SUBJECT: Forwards addl info to support 870311 application for amend  
 to License NPF-54 & response to questions in Adensam 870323  
 ltr. Revised FSAR pages also encl.

Re: Nine Mile Point Unit 2  
Docket No. 50-410

## ATTACHMENT A

FIGURE 5.4-7

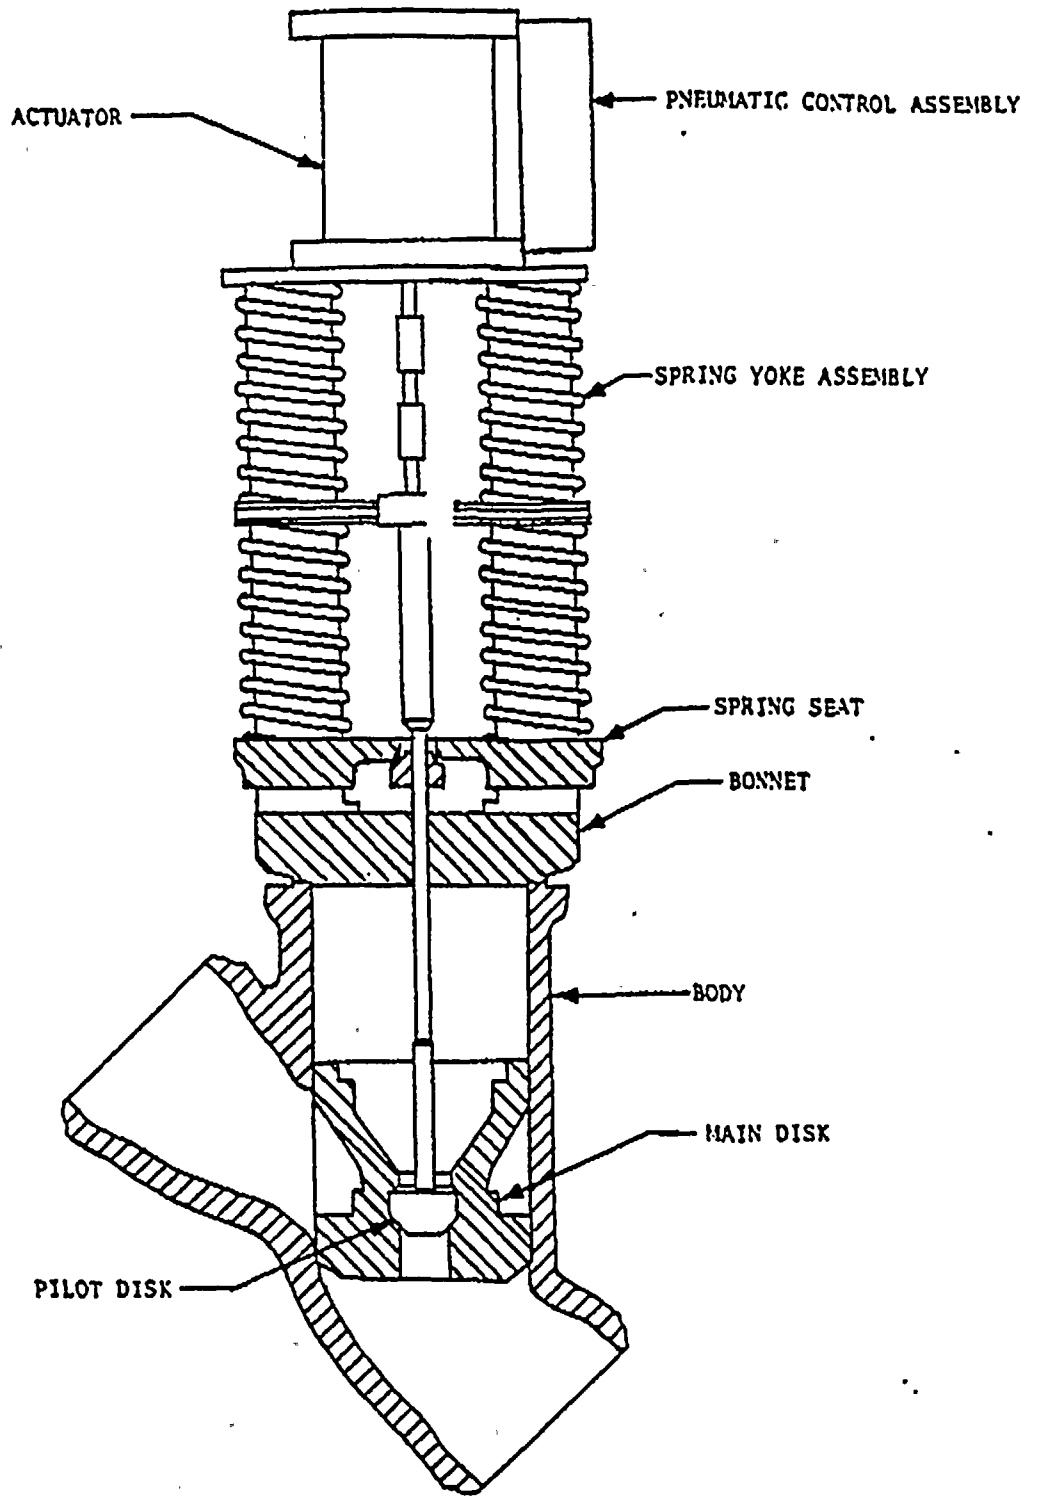
RESPONSE 4: Critical Power Ratio is not the only basis for determining the margin of safety. Each section of the FSAR, and hence each aspect of plant design that affects public health and safety was reviewed to determine the effect on margin of safety. Further, the attached FSAR changes were reviewed and have an insignificant effect on the margin of safety. The changes are provided to make the FSAR consistent. The effect of the instrument air, nitrogen and pneumatic actuator changes are

discussed in Response 1. The effect of the change in the position scram setpoint is discussed in Response 6. The change in the FSAR Figure 5.4.7 and Table 3.2-4 are administrative only. These changes have an insignificant effect on the margin of safety.
